STATE LEVEL EXPERT APPRAISAL COMMITTEE (SEAC)-DELHI
OFFICE OF DELHI POLLUTION CONTROL COMMITTEE
5th FLOOR, ISBT BUILDING, KASHMERE GATE, DELHI-110006

MINUTES OF MEETING

Minutes of the 106th Meeting of State Level Expert Appraisal Committee (SEAC) held on 18.06.2022 at 11:00 AM in the Conference Room of DPCC, at 5th Floor, ISBT Building, Kashmere Gate, Delhi 110006.

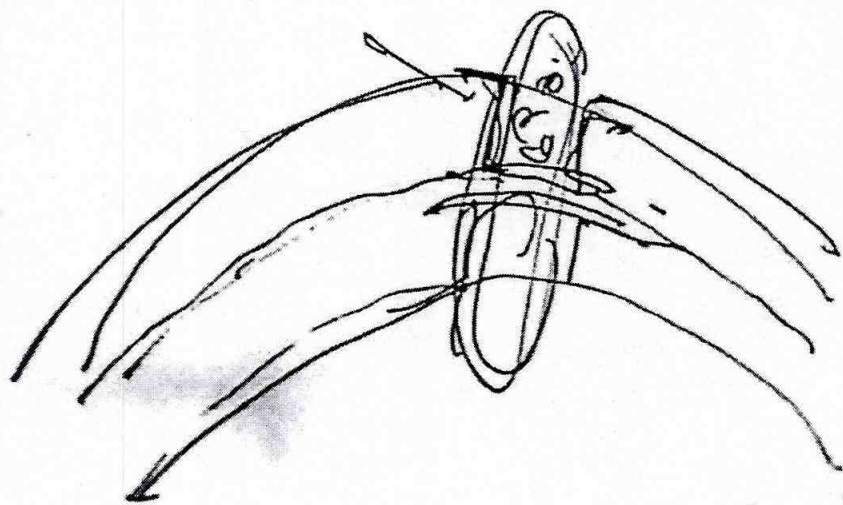
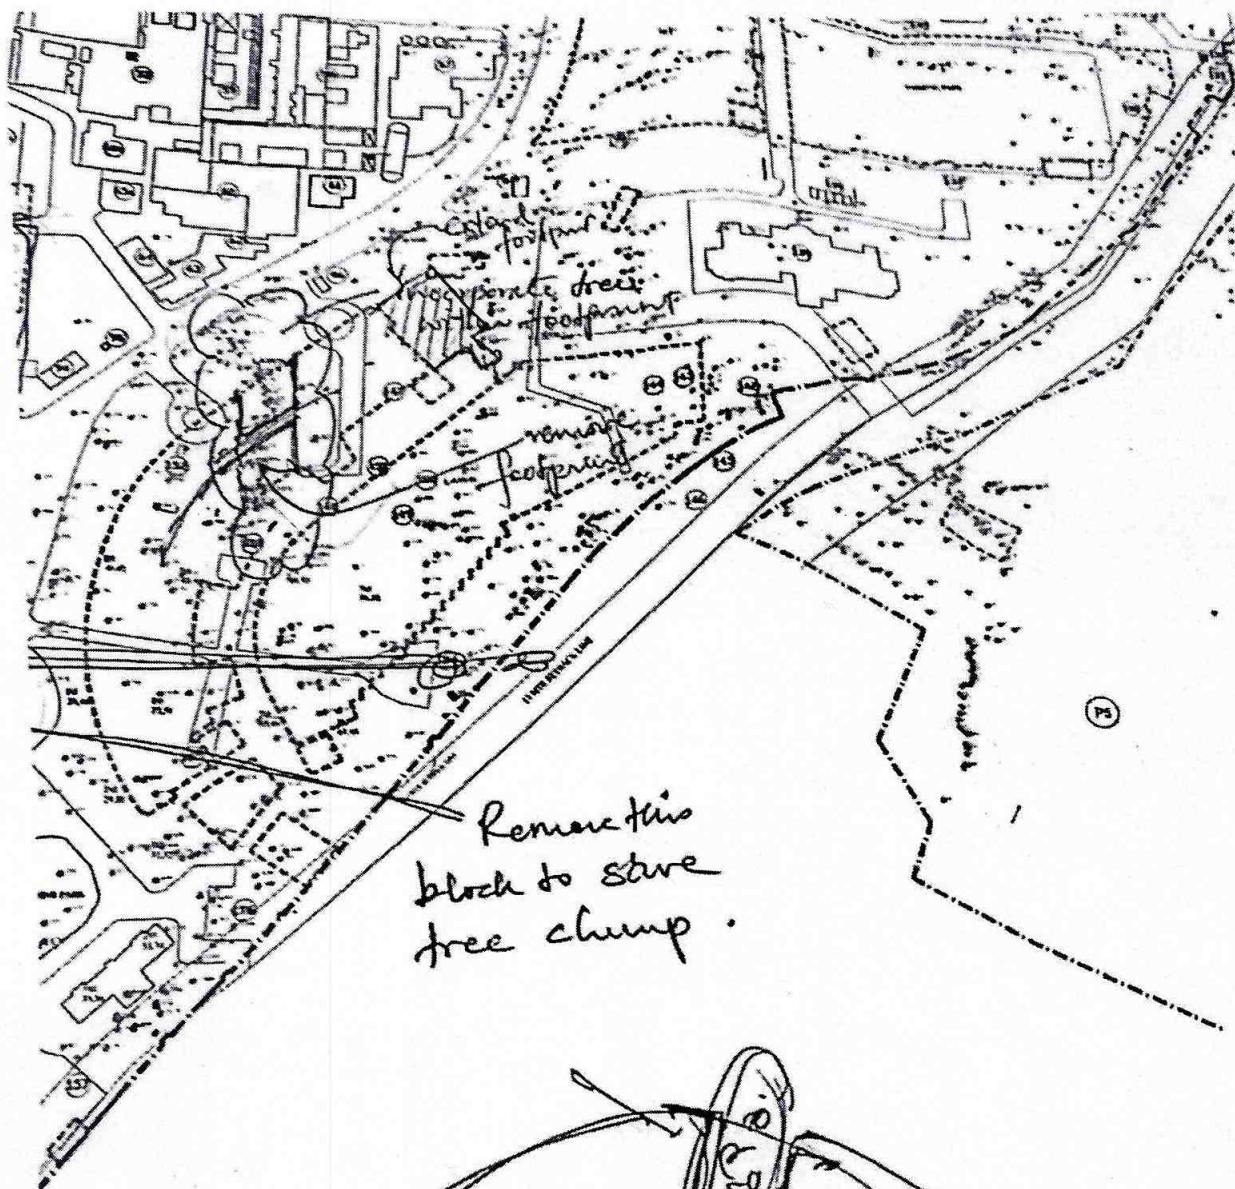
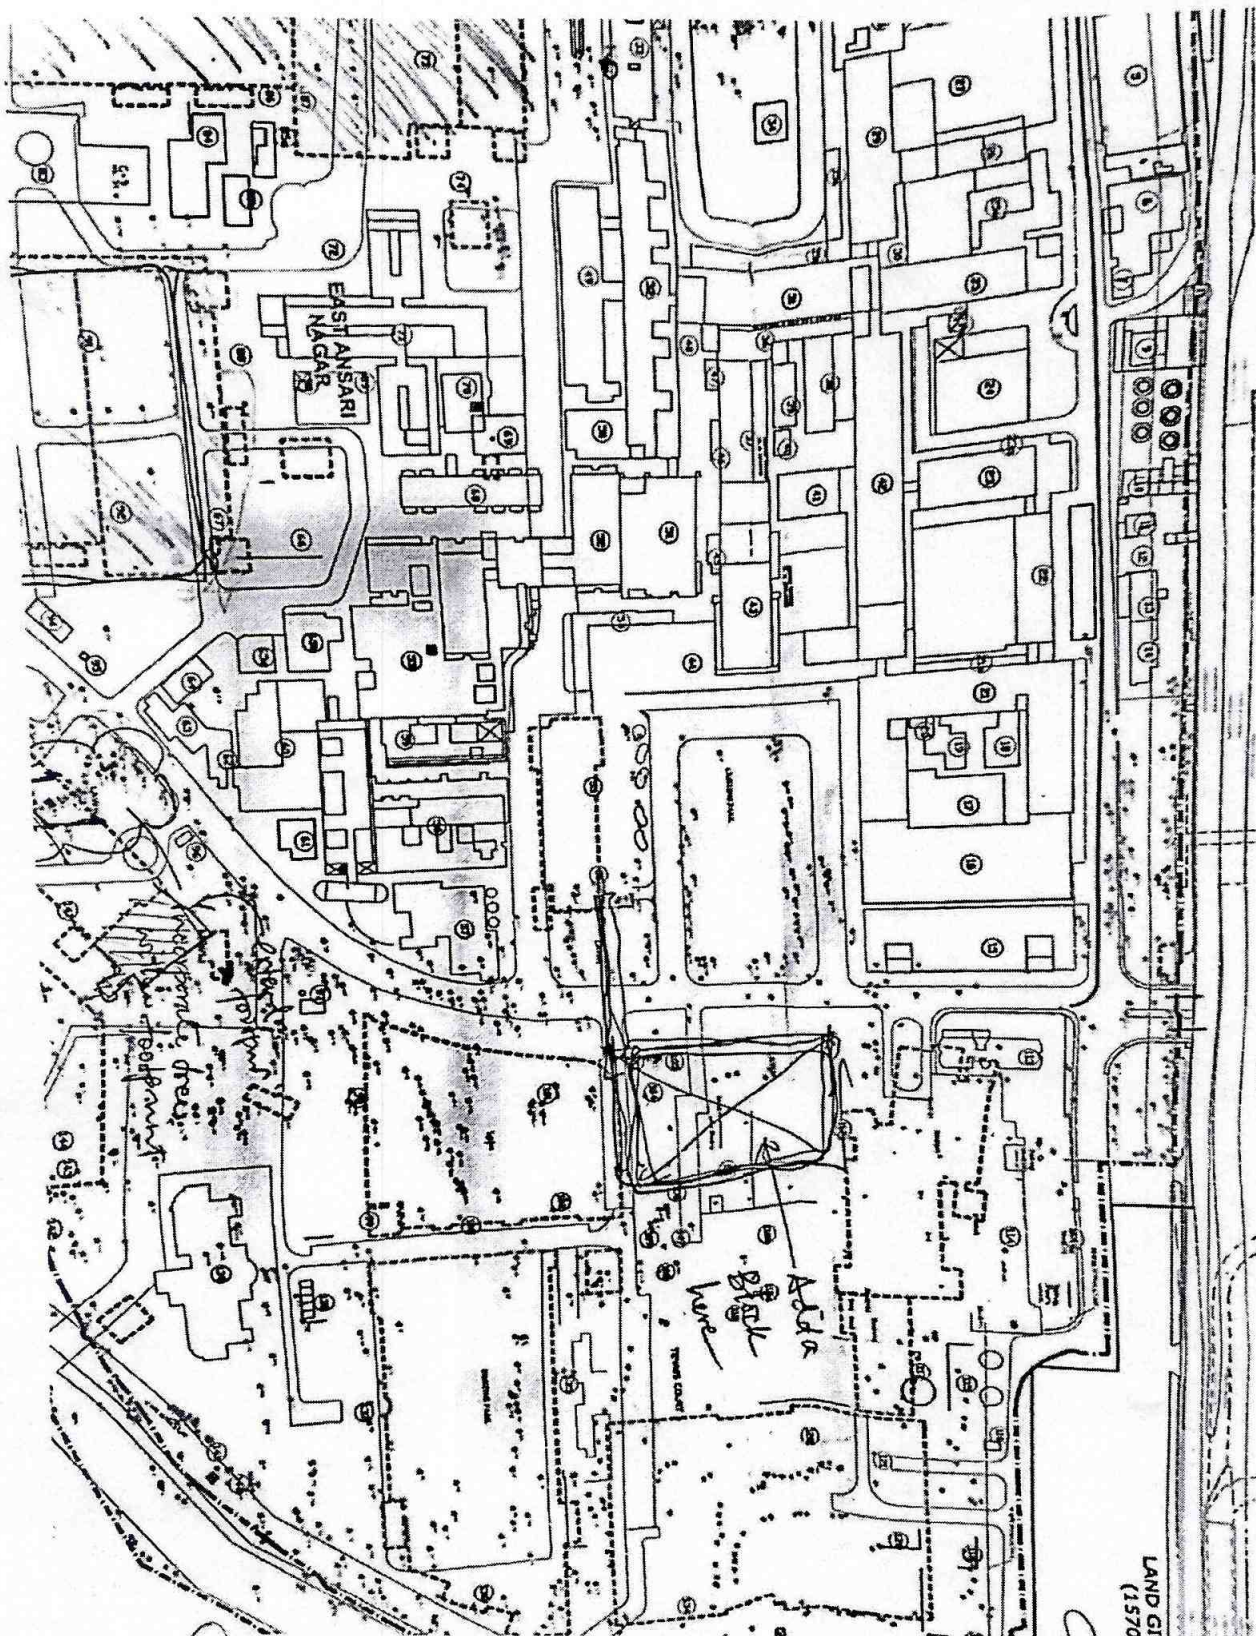
4. Clarifications/ necessary modifications regarding Energy & Sustainable Building Design be provided with -

1. The lighting and ventilation methodology of larger footprint podium/ basement areas needs to be justified.
2. Emergency exit plans
3. Daylighting plan for all habitable spaces
4. Building design strategies to preserve more trees within the proposed footprints. (Refer sketches enclosed).
